STATE OF MAINE
DEPARTMENT OF TRANSPORTATION
16 STATE HOUSE STATION
AUGUSTA, MAINE 04333-0016

November 10, 2022
Subject: Bridge Rehabilitation
State WIN: 021751.01
Location: **Southport & Boothbay Harbor**
Amendment No. 3

Please make the following changes to the bid documents:

SOUTHPORT BRIDGE ROUTE 27
OVER TOWNSEND GUT
SOUTHPORT & BOOTHBAY HARBOR ME LINCOLN COUNTY

ADVANCE WARNING BEACON PLAN

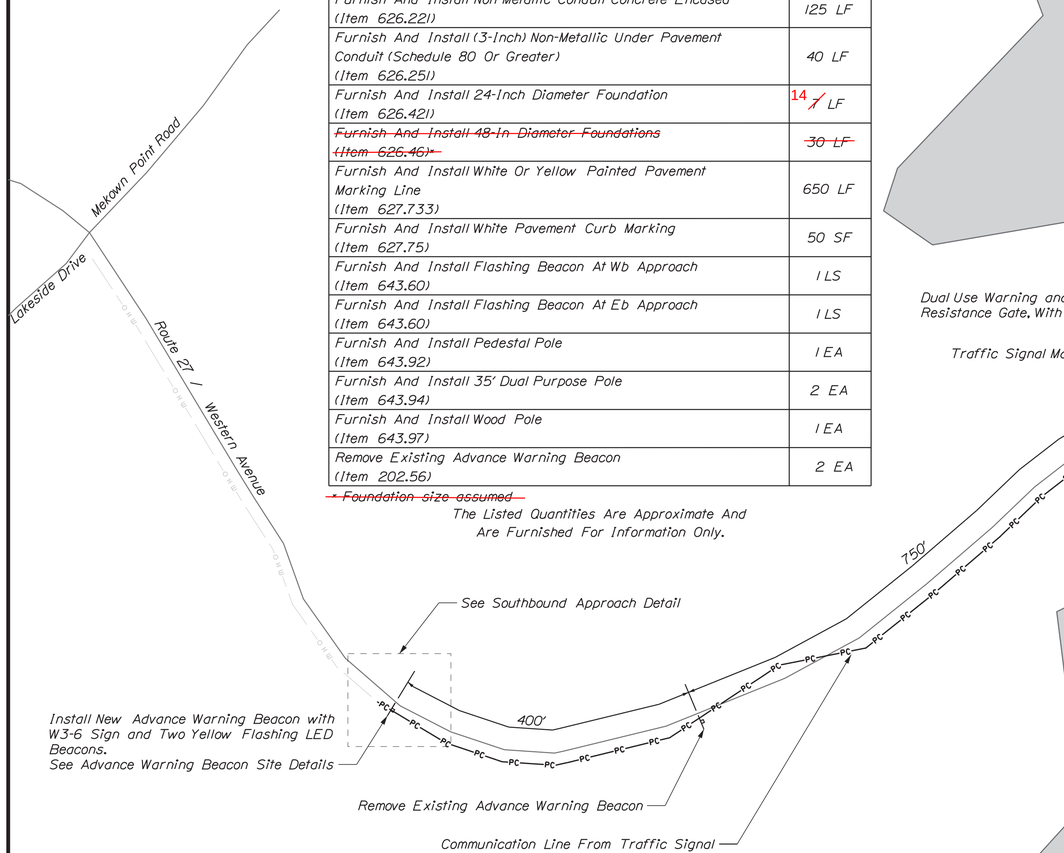
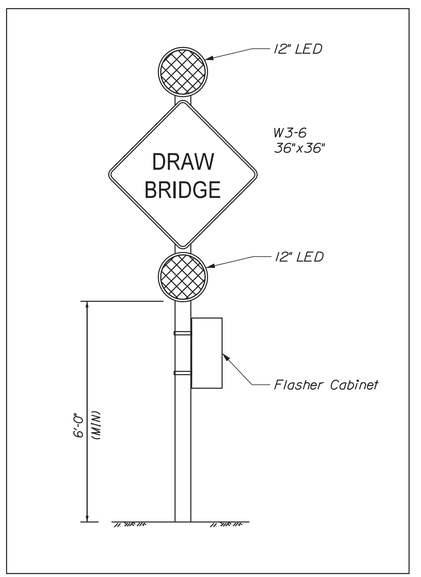
Question: Drawing 45 "Advance Warning Beacon Plan" list of work items indicates 7 feet of 24" foundation associated with the 15-foot Pedestal Pole Structure "SB-P1" Where is this foundation to be paid under?

Response: Per Special Provision Section 643, Traffic Signals (Flashing Beacon) 643.19, the foundations for the Advance Warning Beacons shall be paid for under the 626 items.

SHEET NUMBER
47
OF 48

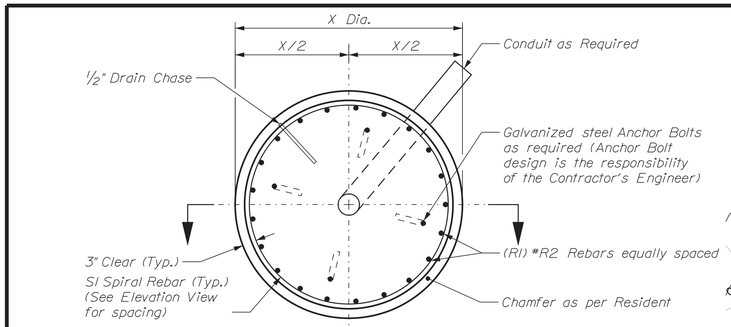
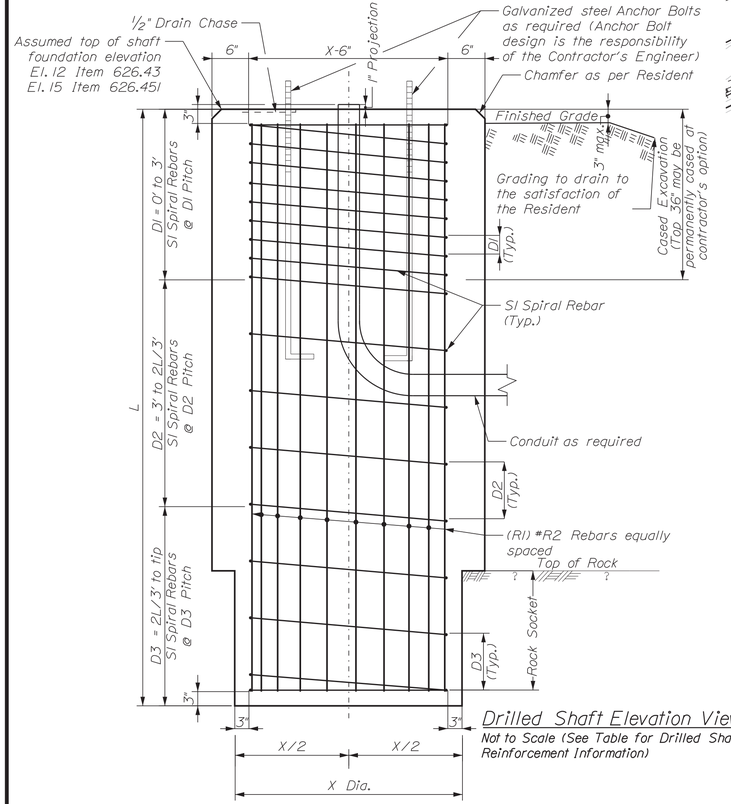
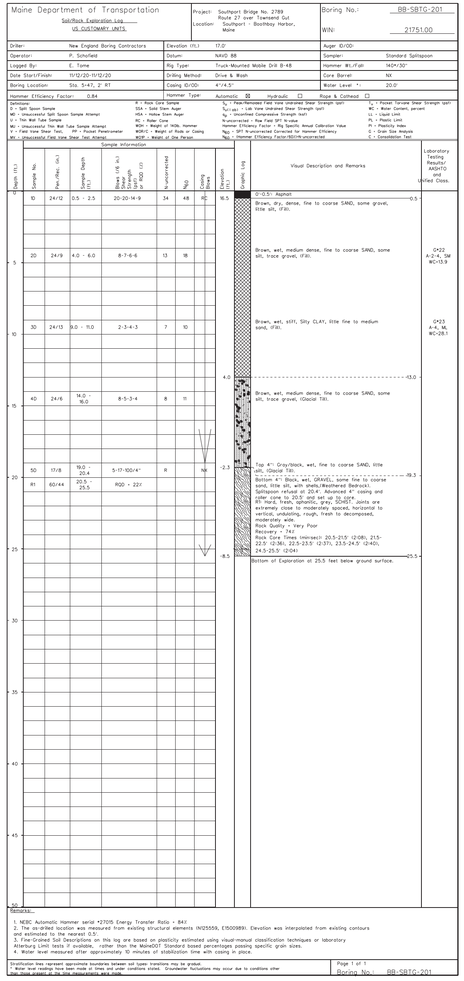
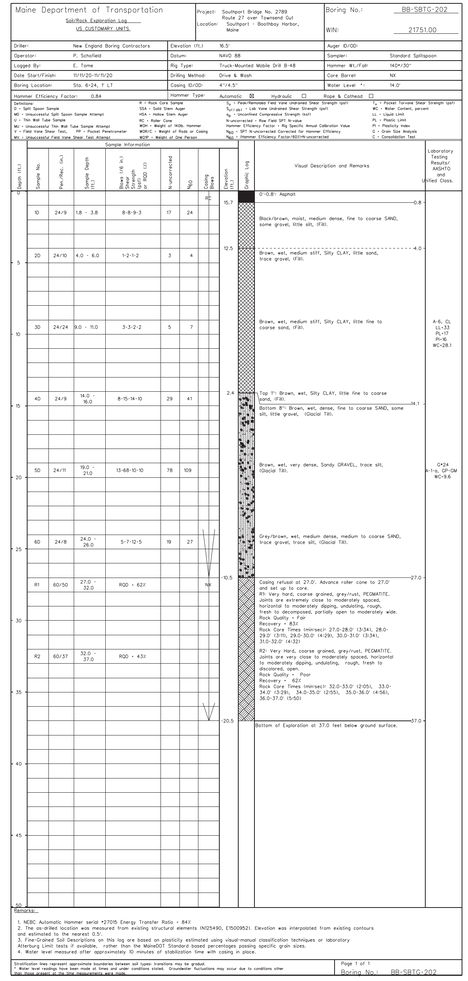
Question: Please confirm there are four drilled shaft foundations required for the New Crash Barrier Gates. Should the drilled shaft tables on sheet 47 and 48 of the plans be revised to reflect this?

Response: It is correct that there are four drilled shaft foundations required for the new crash barrier gates. The tables on sheets 47 and 48 indicate foundation designs. There are two acceptable crash barrier foundation designed presented on sheet 47, depending on contractor preference for shaft diameter. On sheet 48 there are two acceptable mast arm foundation designs depending on whether the contractor encounters rock during installation. See sheet 2 for estimated quantities.

M7 OF M24

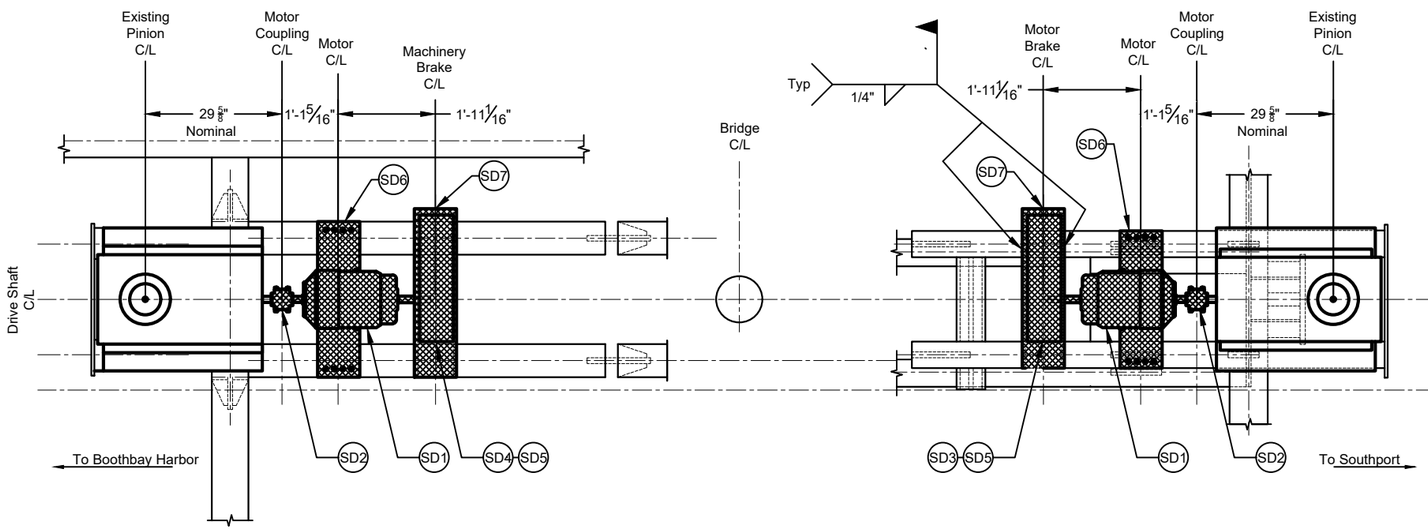
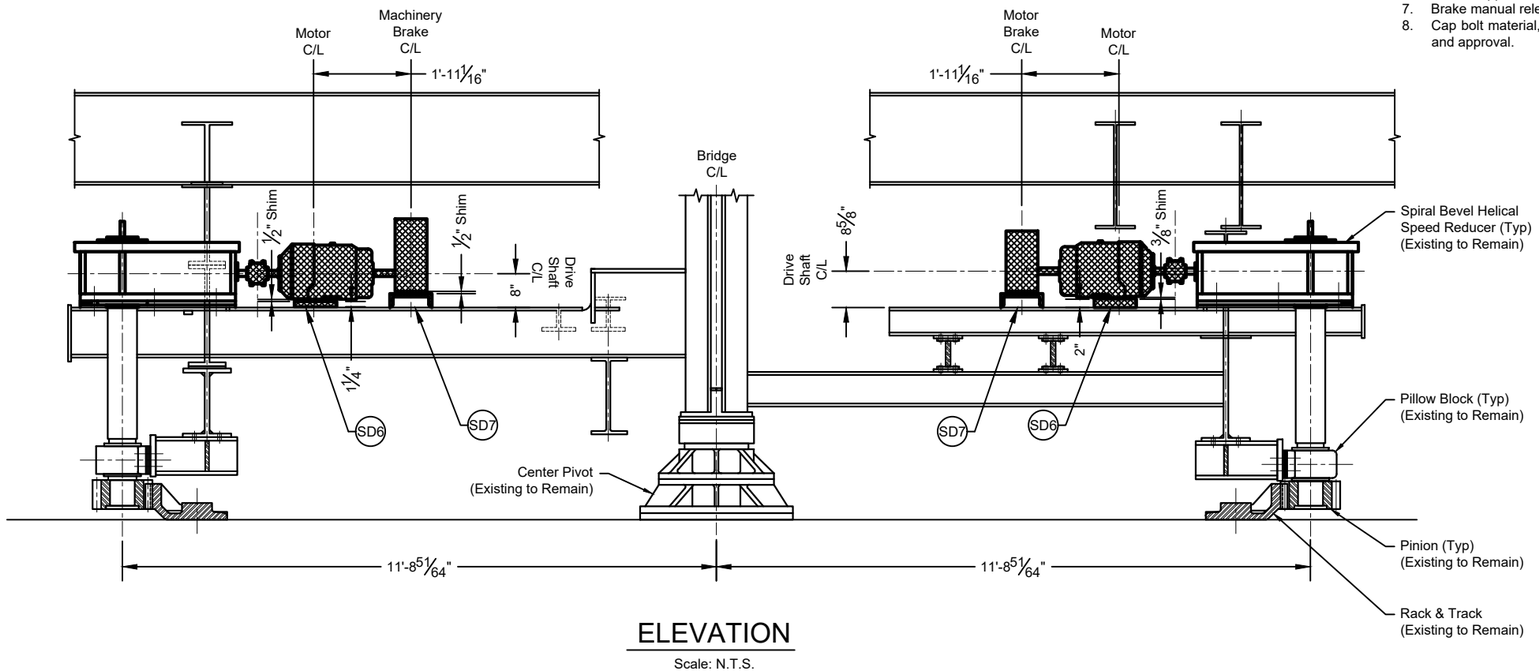
Question: Sheet M7 shows the machinery and motor brakes mounted to the rear shafts of the span drive motors. A statement at the beginning of Specification 860.9.3 states "Each thrustor brake shall be mounted on their support channels at the rear shaft of their respective motors." Another statement midway through 860.9.3 states, "The thrustor brake wheel shall be mounted on the reducer input shaft..." Please clarify.

Question: Sheet M7 contains the Span Drive Machinery Schedule. Mark No. SD6 requires a quantity of 8 Motor supports. Based on the quantity of Span Drive motors and the details on the drawing it appears only 2 are required. Please clarify.

Question: Sheet M7 contains the Span Drive Machinery Schedule. Mark No. SD7 requires a quantity of 8 Brake supports. Based on the quantity of Brakes and the details on the drawing it appears only 2 are required. Please clarify.

Response: In pen and ink strike through the last bullet point of section 860.9.3 and replace with “The thruster brake wheel shall be mounted on the span drive motor rear shaft with an FN2 fit and key.”

Response: Sheet M7 is revised to indicate an SD6 quantity of 2 instead of 8, one (1) Motor Support for Southport side and one (1) Motor Support for Boothbay side.

Response: Sheet M7 is revised to indicate an SD7 quantity of 2 instead of 8, one (1) Brake Support for Southport side and one (1) Brake Support for Boothbay side.

NEW END SEAT AND END JACK
MACHINERY SCHEDULE AND ARRANGEMENT

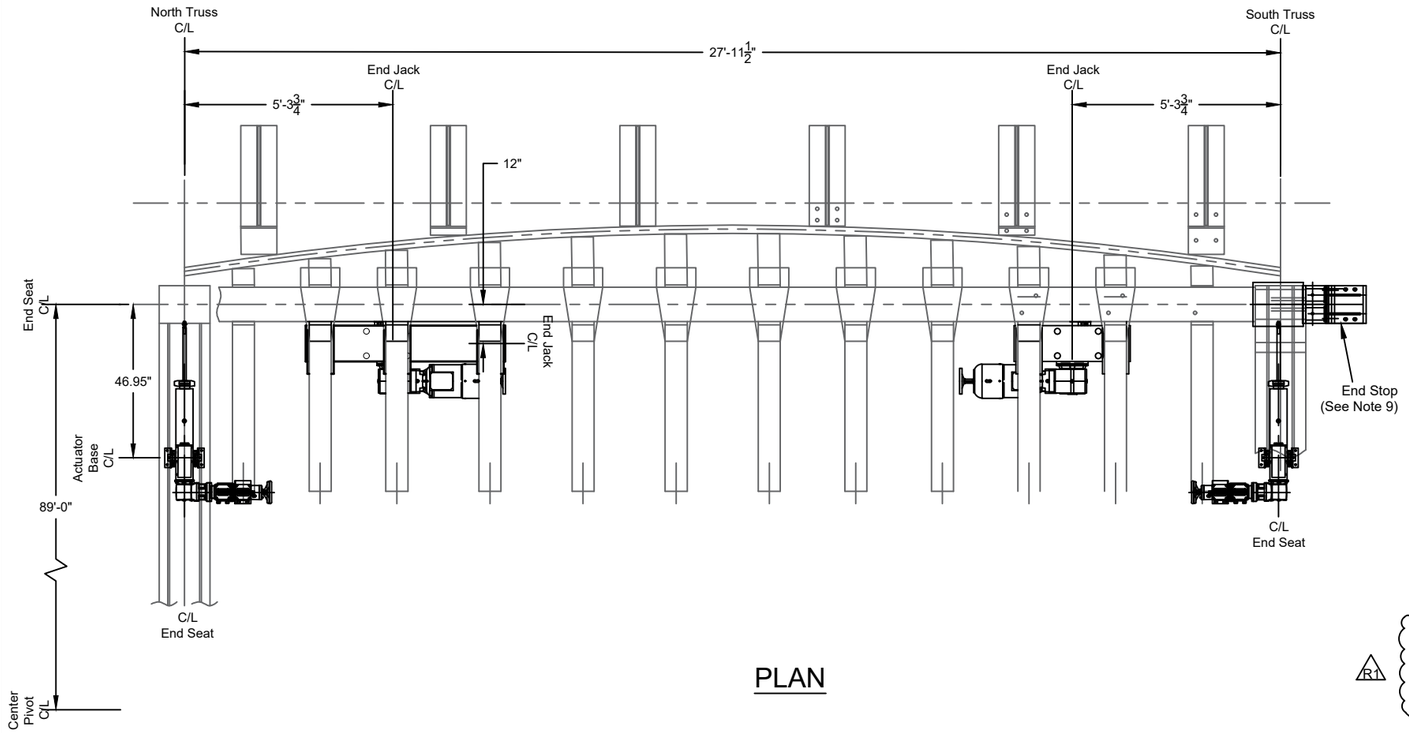
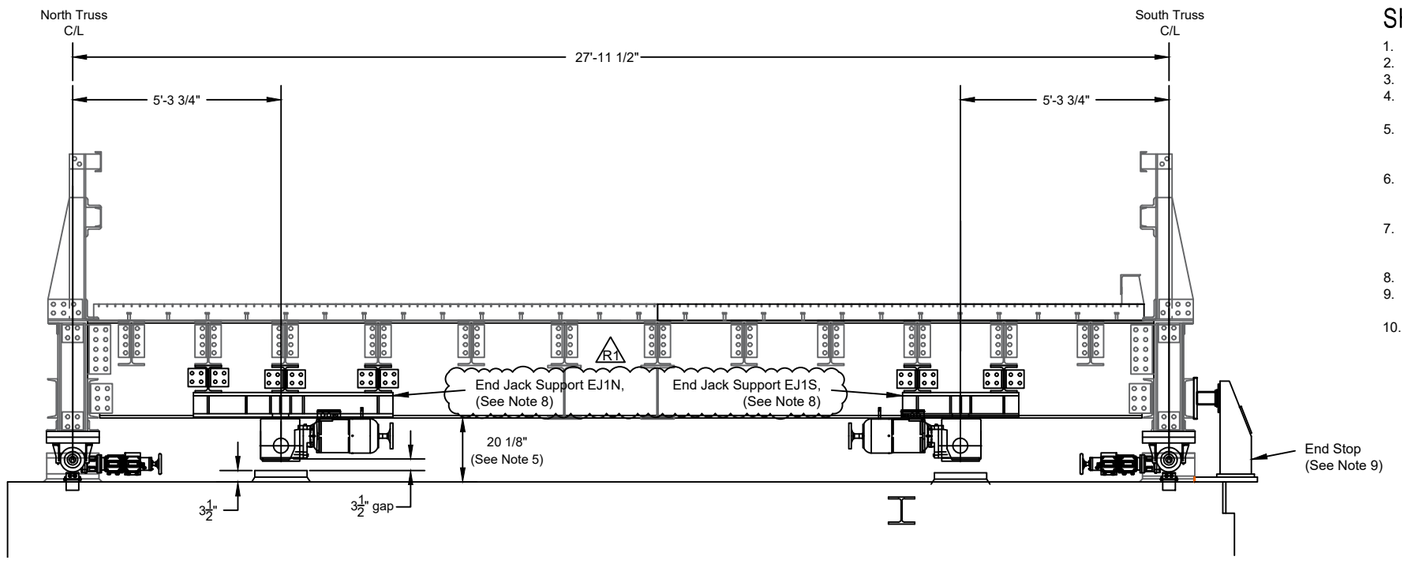
Question: Note 3 on Sheet M16 references End Jack Support, EJ1, details on the Structural Sheet titled "Jacking Support Details". Sheet 32 shows the End Jack Support detail but does not reference detail EJ1. Please clarify.

Response: Sheet M15 Note 3 was meant to be referenced in the question. Sheet M15 has been revised for Note 3 and callouts for EJ1 to be EJ1N & EJ1S to distinguish between north and south end jack supports. Also see revised sheet M11. Sheet 32 shows the structural details for EJ1N and EJ1S.
